ADDENDUM NO. 02

PROJECT: South Ridge Community Park – Enhancement Plan 2019
1450 Freeman Road
Hoffman Estates, IL
W-T Project #1911354C

DETAIL - SYNTHETIC TURF ADJACENT
TO PLAYGROUND CURB
NOT TO SCALE

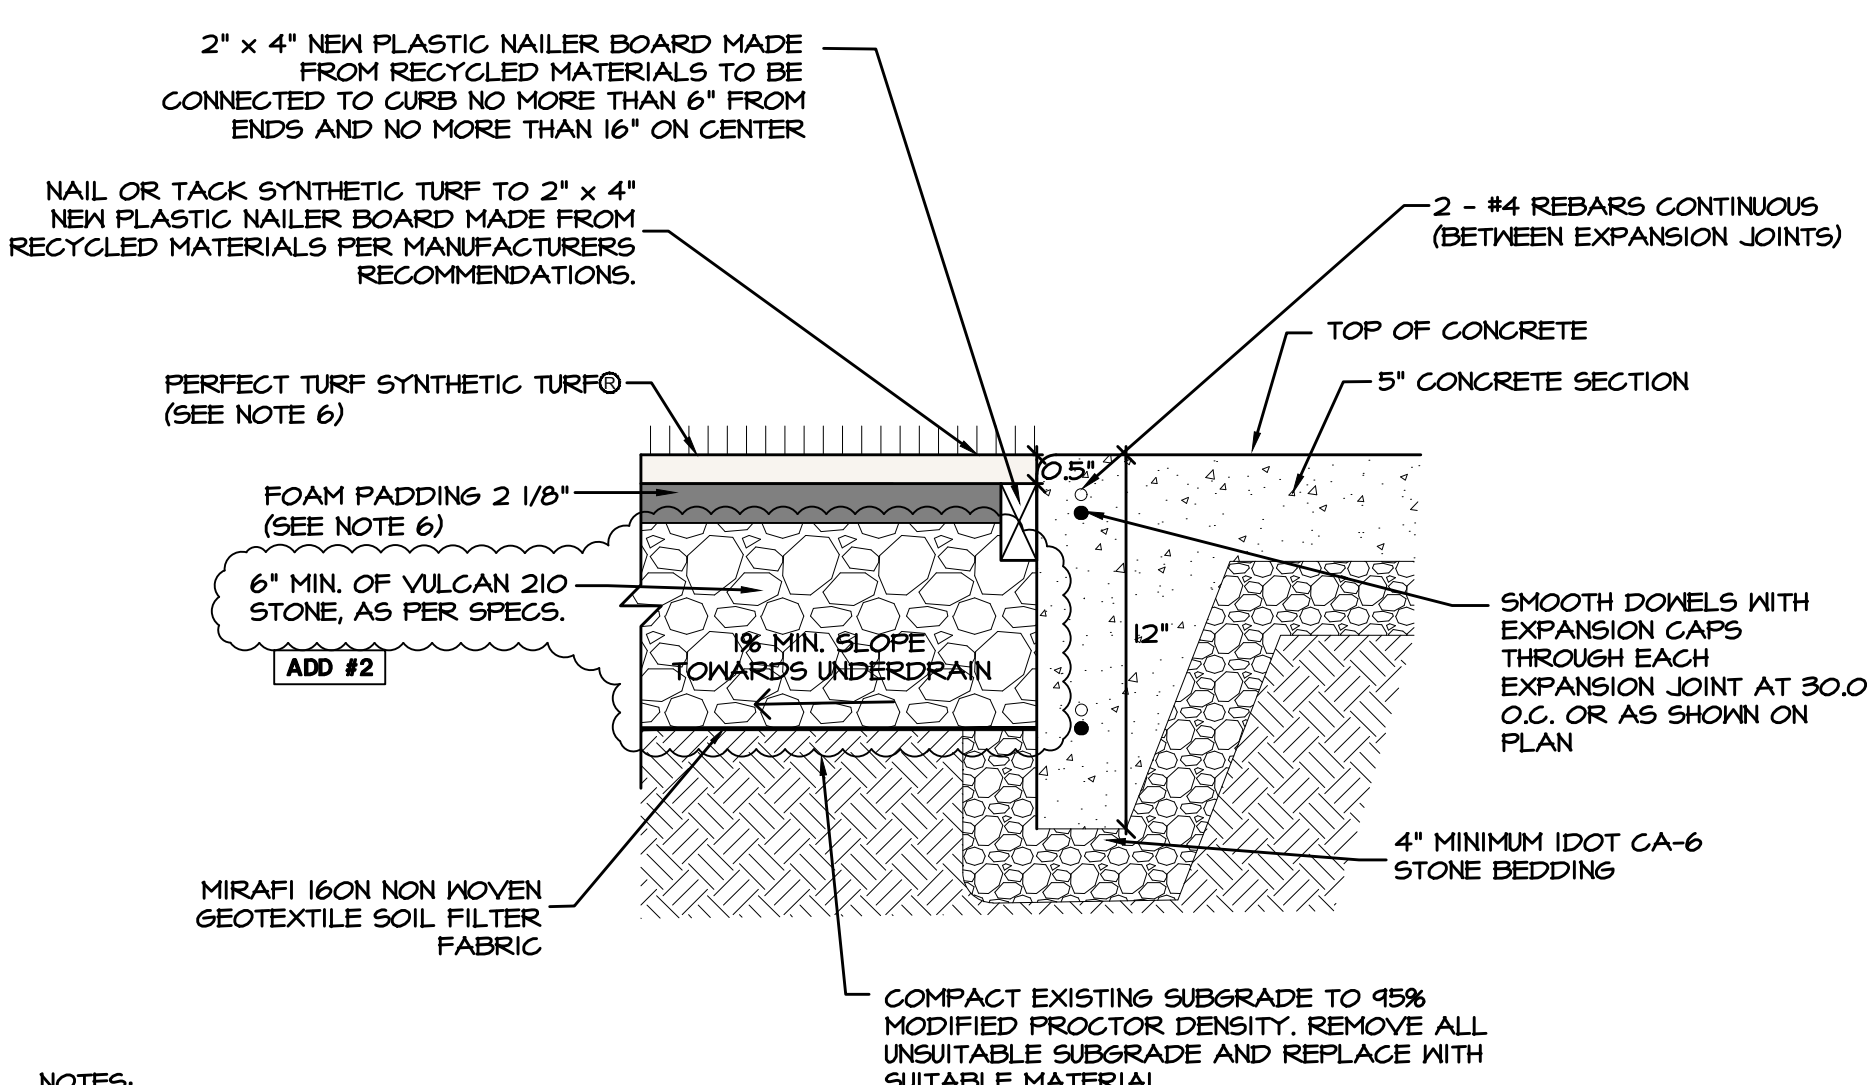
- a. Detail – SYNTHETIC TURF ADJACENT TO PLAYGROUND CURB: Aggregate base changed to 6" min. of Vulcan 210 stone. Aggregate thickness underneath playground curb shall be 4" minimum CA-6 granular base.
- b. Detail – SYNTHETIC TURF ADJACENT TO MONOLITHIC PLAYGROUND SIDEWALK: Aggregate base changed to 6" min. of Vulcan 210 stone.

DETAIL - PLAYGROUND TRANSITION CURB
NOT TO SCALE

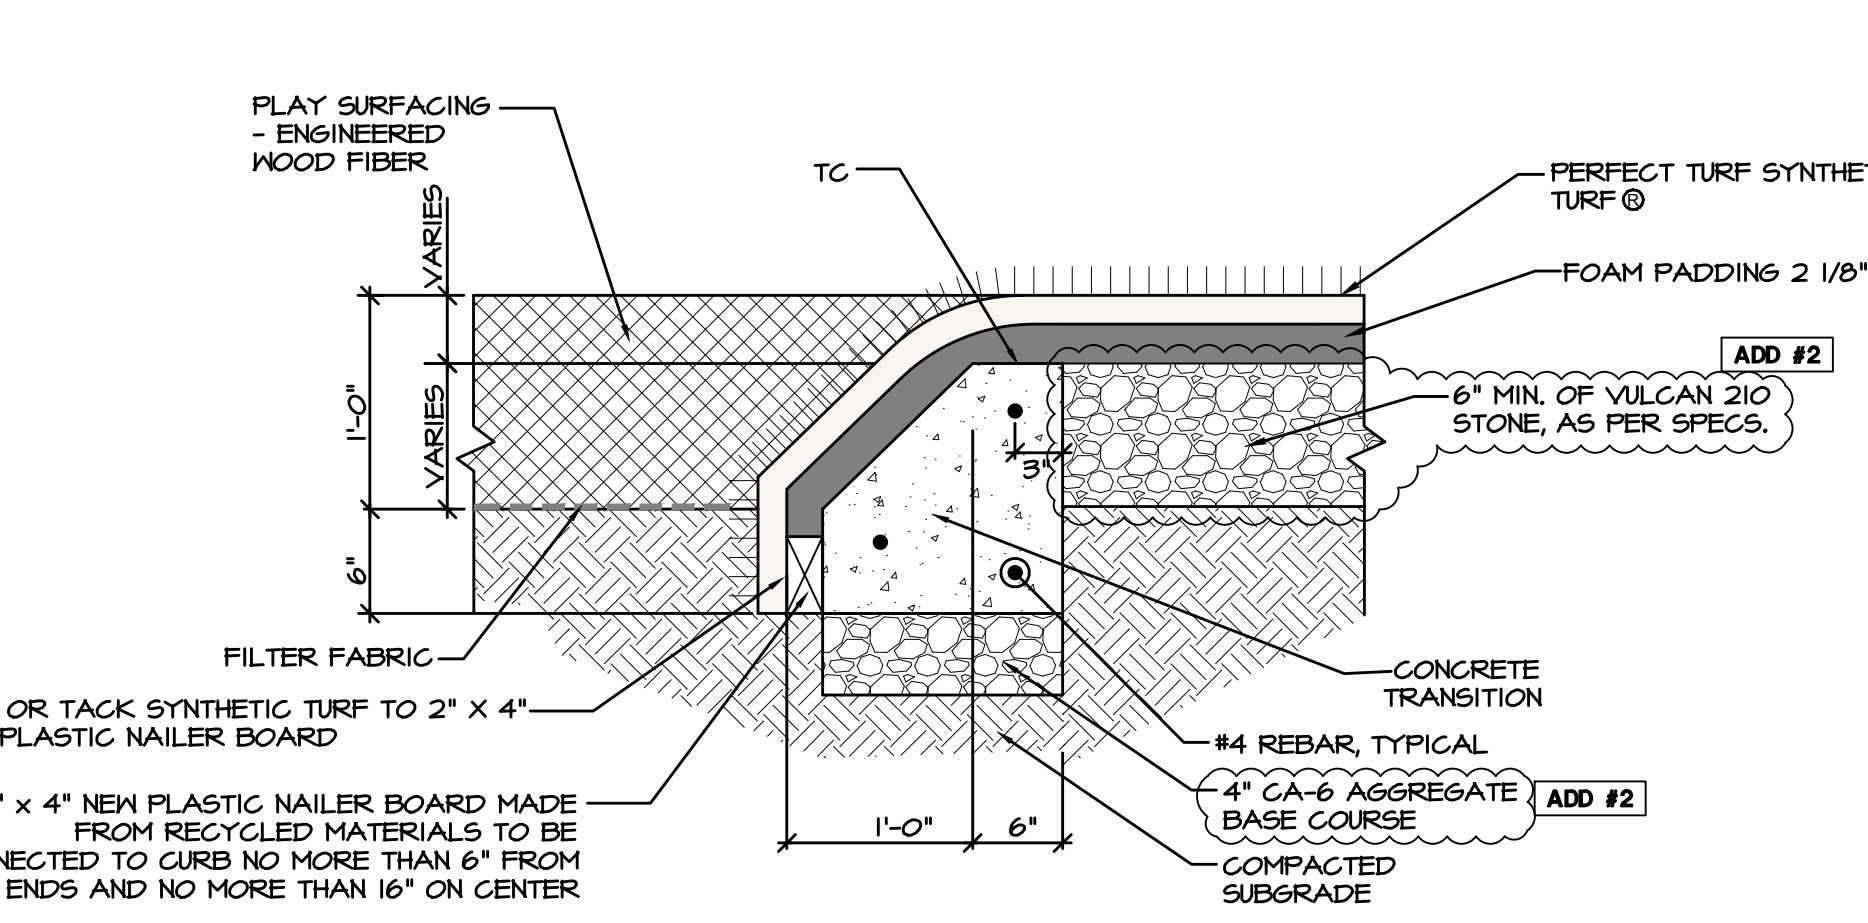
- c. Detail – PLAYGROUND TRANSITION CURB: Aggregate base changed to 6" min. of Vulcan 210 stone. Aggregate thickness underneath transition curb shall be 4" minimum CA-6 granular base.
